# Product Change Notification

**Change Notification #:** 116527 - 00  
**Change Title:** Intel® Compute Module HNS2600BPBLC24  
Intel® Compute Module HNS2600BPBLC,  
PCN 116527-00, Product Design,  
BMC/FRUSDR Firmware Update in Factory  
and Mechanical Improvements in Power  
Docking Board  
**Date of Publication:** October 04, 2018

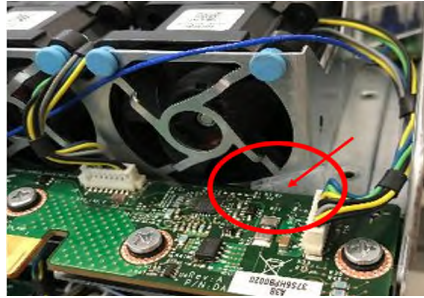
1. BMC Factory Firmware Update to version 1.43g
2. FRUSDR Factory Firmware Update to version 1.36
3. Rubber collar addition to allow more floating for Power Docking Board on left-right direction for a better connection

4. Addition of Plastic Filler between Power Docking Board and Fan Cage to decrease the Power Docking Board Rotation when compute node is inserted
